# Access Compliance Report

## Public Rights-of-Way

### (Island Curb Cuts)

| Intersection ID: 51704                  | Main Street: IKEA_BV         | Cross Street: N/A                       | Location:              | N                  |

| ADA ID: 3F16F94B0E52                    | Curb Cut Type: MedianRefuge2 | Initial Pass/Fail: Fail                 | Overall Compliance: No | Severity Score: 10 |

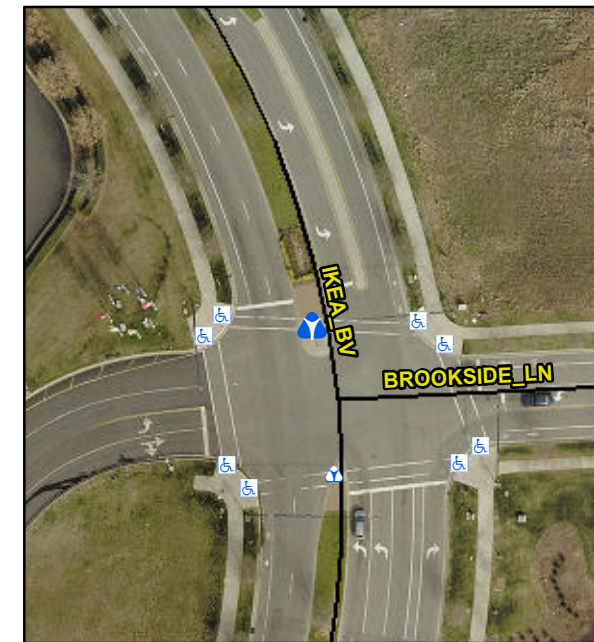
**Remove & Replace Entire Refuge.**

| Compliance | Description          | Data  | Compliance | Description                 | Data |
|------------|----------------------|-------|------------|-----------------------------|------|
| No         | Refuge 1 Width (In)  | 59.0  | N/A        | Gutter 1 Lip Ht (In)        | N/A  |
| No         | Refuge 2 Width (In)  | 59.0  | N/A        | Gutter 2 Lip Ht (In)        | N/A  |
